Three Mile Island Nuclear Station Temporary Change Notice (TCN)

12. TCN No. 1-83-0235 (From TCN Log Index)

1. Procedure 1004.4 10 General Emergency
No. Present Rev. No. Title

1. Procedure 1004.15 3 Post Accident Tm-Plant Sampling
No Present Rev. No. Title

ATTACHMENT I SECTION IV
PROTECTIVE ACTION RECOMMENDATION GUIDELINES

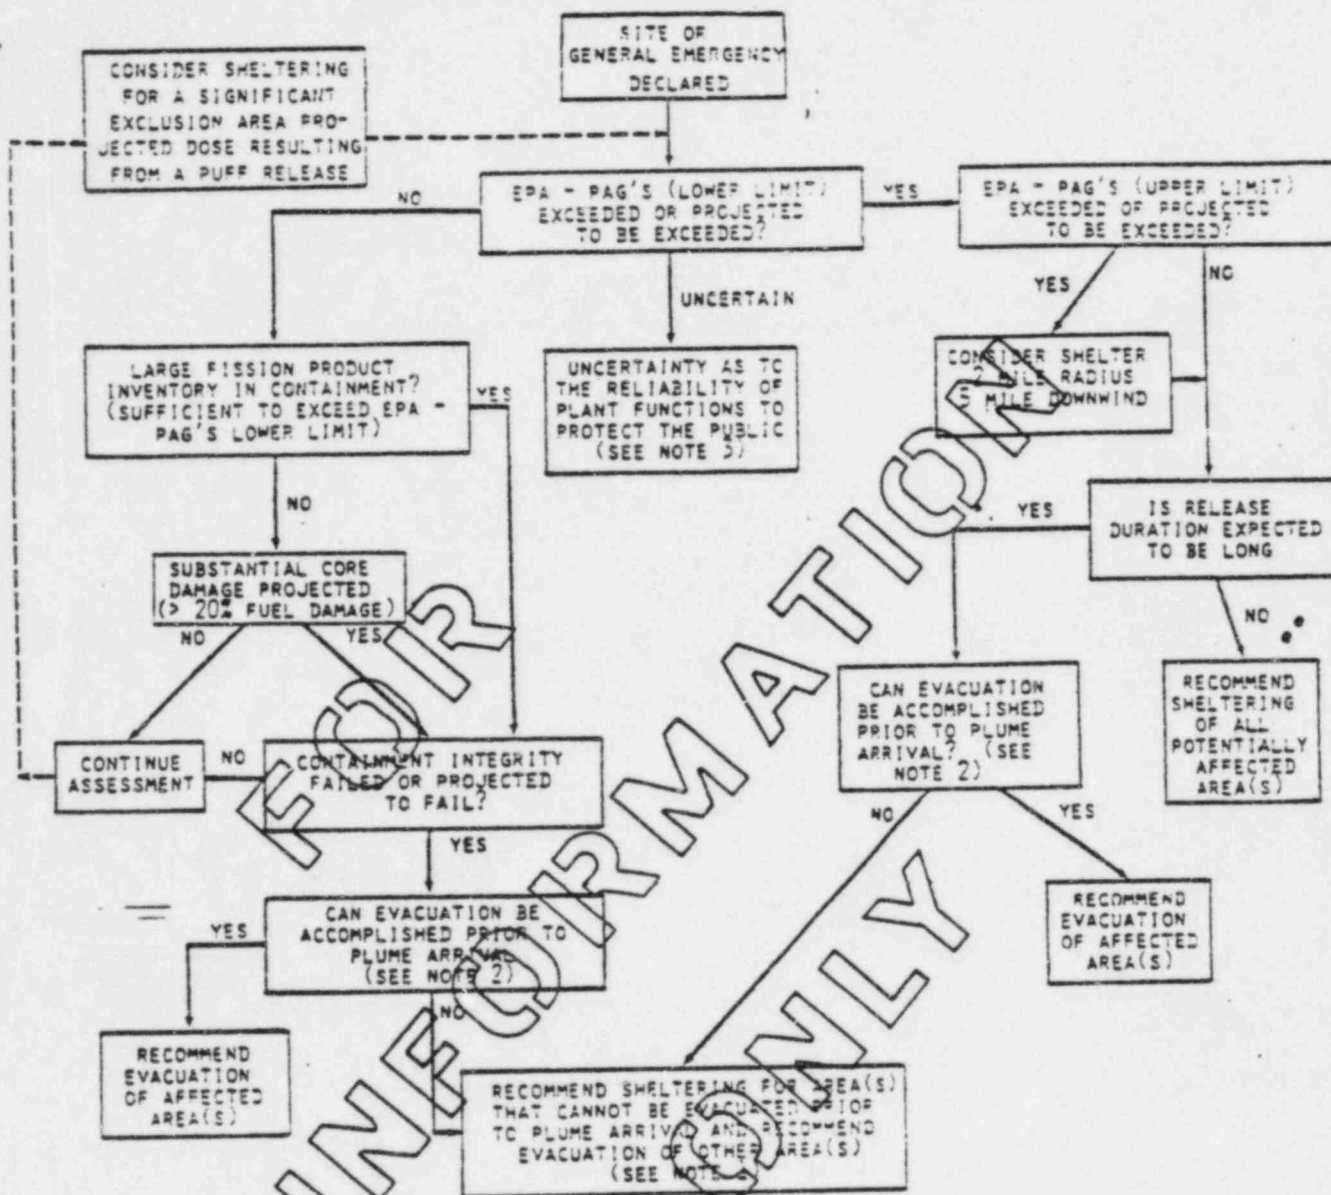
Page 24.0 Attachment 1, Section IV - To be replaced by a new Attachment 1, Section IV.

3. Reason for Change:
To provide better guidance in PAR decision making.

This Change involves replacement of Attachment 1 with a PAR Matrix. It does not increase the probability or possibility of an accident nor reduce the margin of safety as defined in the Tech. Specs.

ATTACHMENT 3: POST ACCIDENT SAMPLING SYSTEM VALVE SCHEMATIC

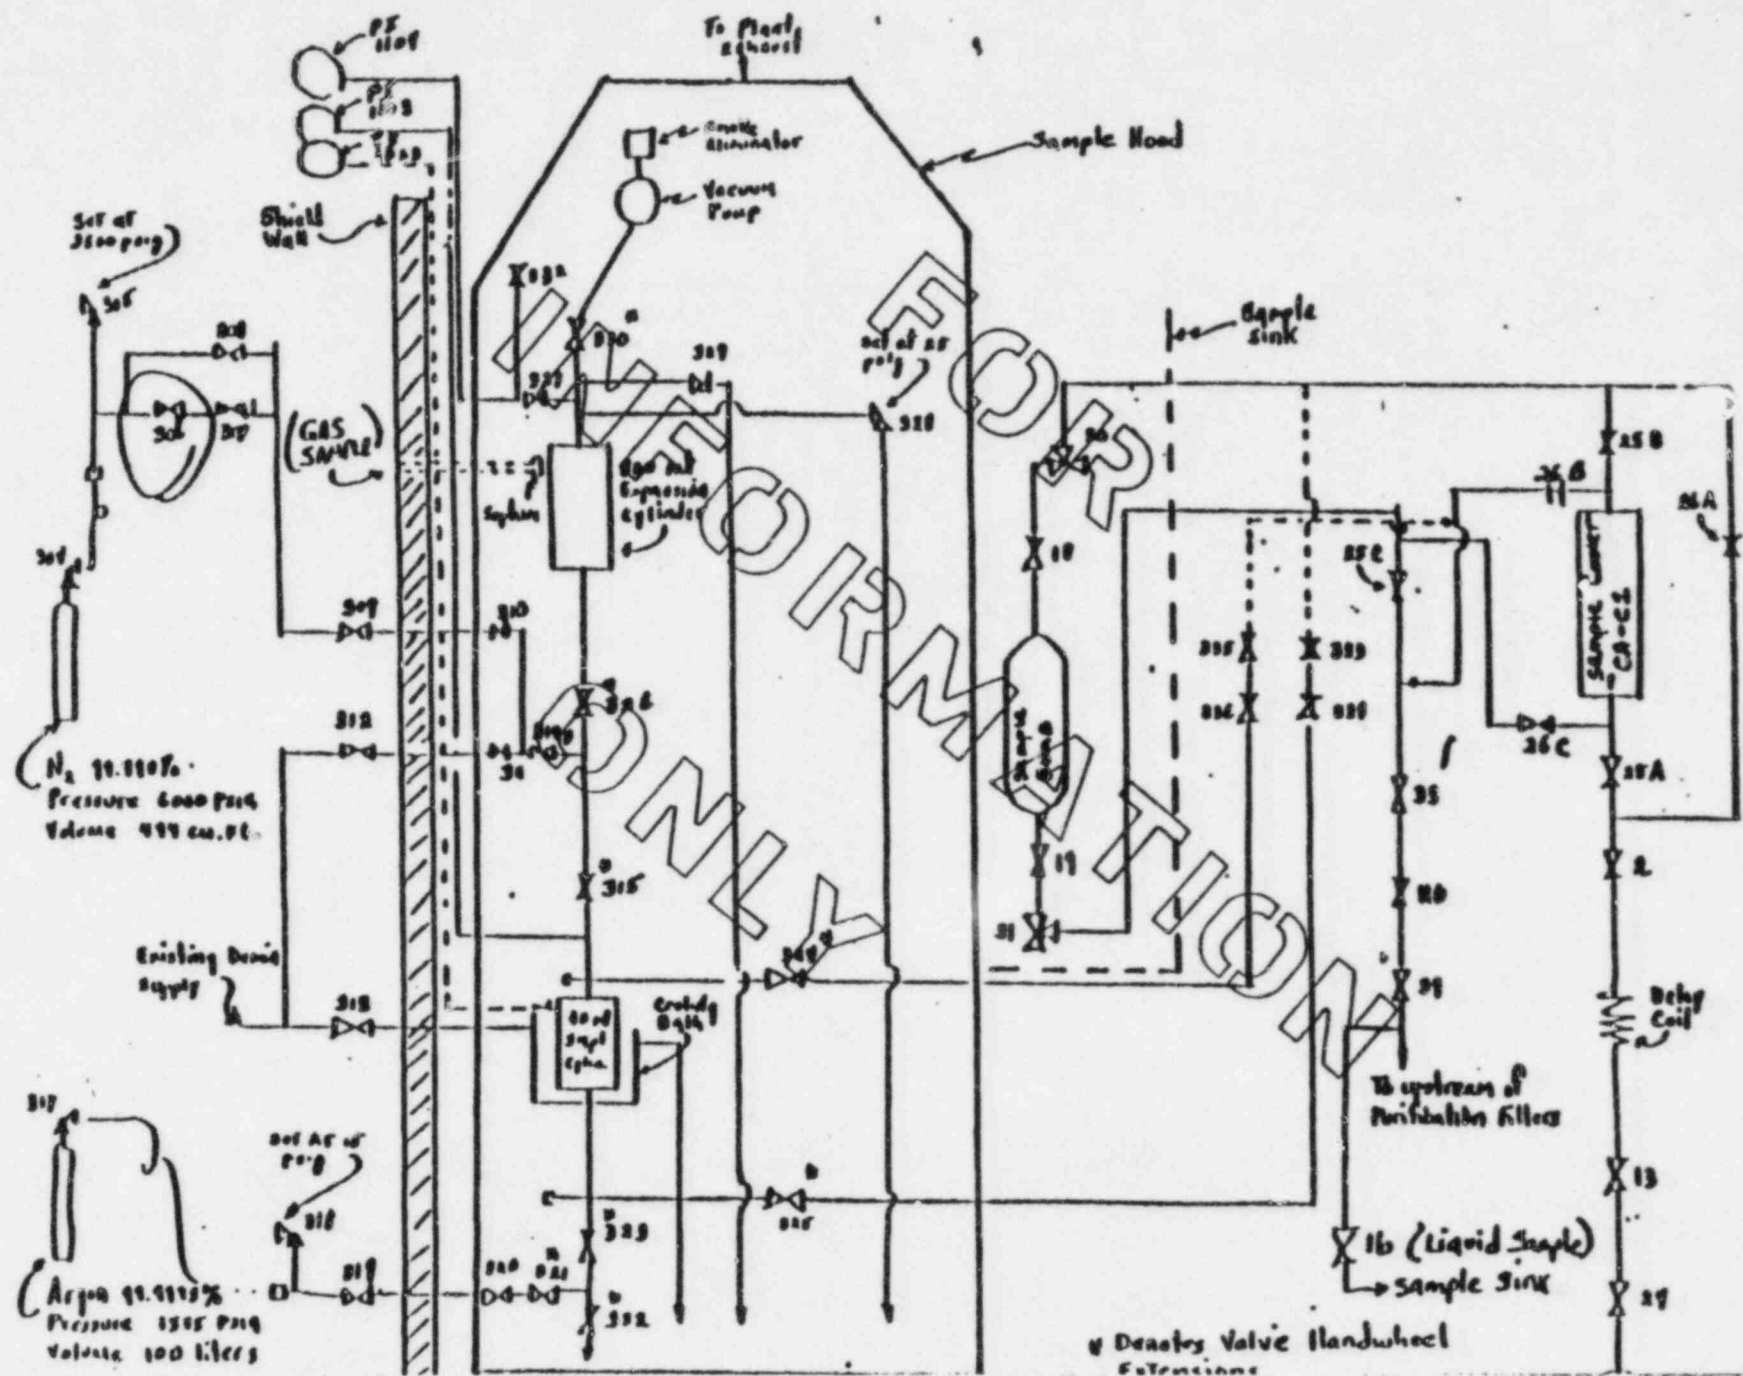
changes are required as shown in attached copies

this change is intended to narrow the scope of the procedure and add clarity
